#04-03-08-006E: Steering and Front Suspension Noise Concerns-Clunk, Thump, Rattle, Knocking, Pop, Shudder, Vibration (Diagnose and Perform Necessary Repair) - (Nov 1, 2010)

Models: 2005-2010 Chevrolet Cobalt (Including SS)
2006-2010 Chevrolet HHR (Including SS)
2005-2006 Pontiac Pursuit (Canada Only)
2007-2010 Pontiac G5
2003-2007 Saturn ION

This bulletin is being revised to add 2010 model year and update Condition #7 with new part information. Please discard Corporate Bulletin Number 04-03-08-006D (Section 03 - Suspension).

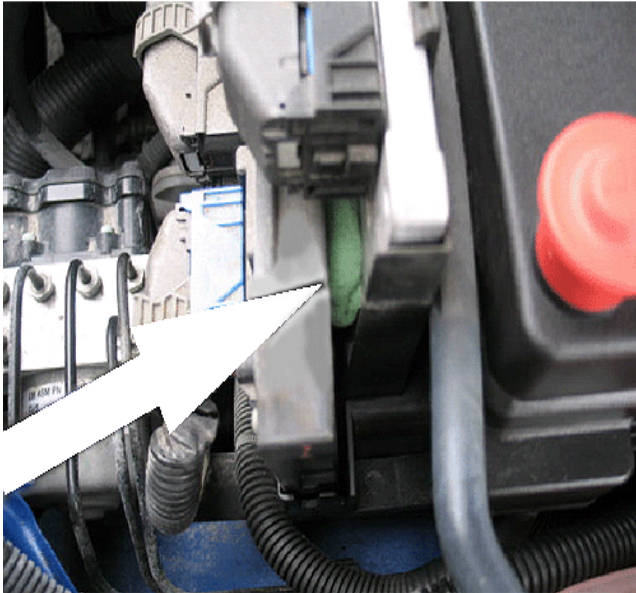
Cause #4

This condition may be caused by inadequate lubrication of the steering intermediate shaft.

Correction #4

Important: DO NOT replace the steering gear or steering column assembly.

Replace the intermediate shaft.

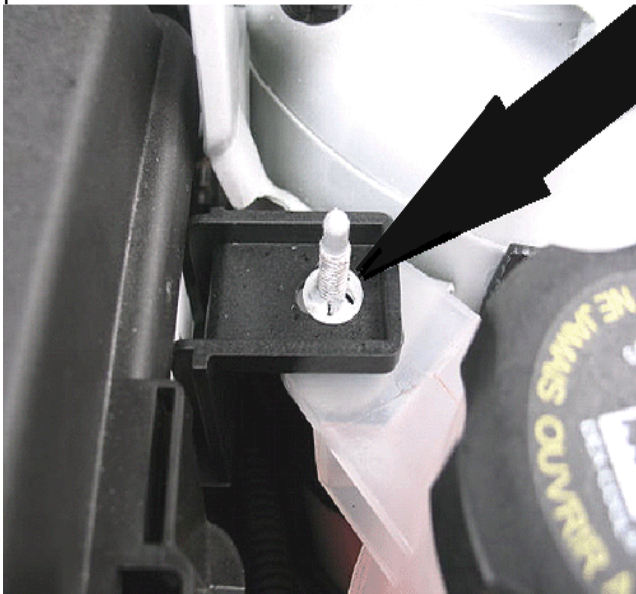
Some customers may comment on a rattle/clunk type noise coming from the steering column when driving over bumps.

1. Check for the possibility of the PCM and the TCM rattling/clunking together. If there is contact between these two modules, insulate the modules from each other using a small piece of foam.

2. Check that the retaining clip on the engine coolant surge tank is fully seated. If not, push down to seat.

Rattles/clunks in this area of the engine compartment may be heard as coming from the steering column while driving.

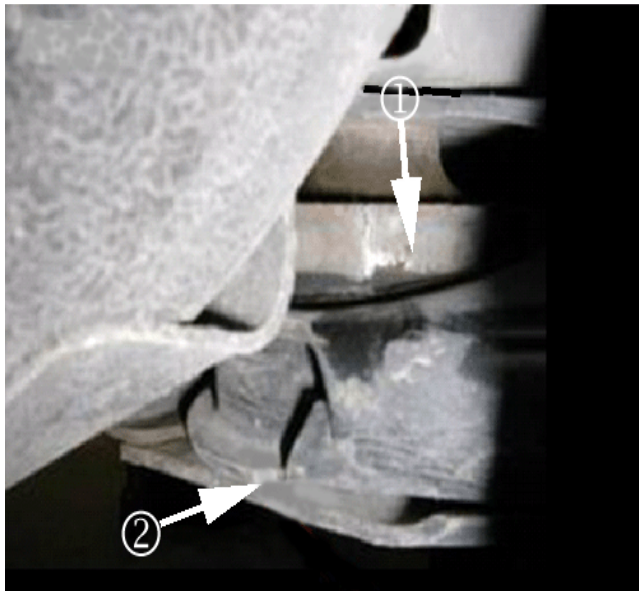
Cause #6

This condition may be caused by the lower control arm rubber bushing (rear) coming out of its steel sleeve (1). This will cause the lower control arm to make hard contact (2) with the body structure. This condition may be more prevalent in regions that use road salt during the winter months.

If the rubber bushing has moved out of the steel sleeve, replace the lower control arm bushing. Do not replace the bushing if it is still centered in the steel sleeve.
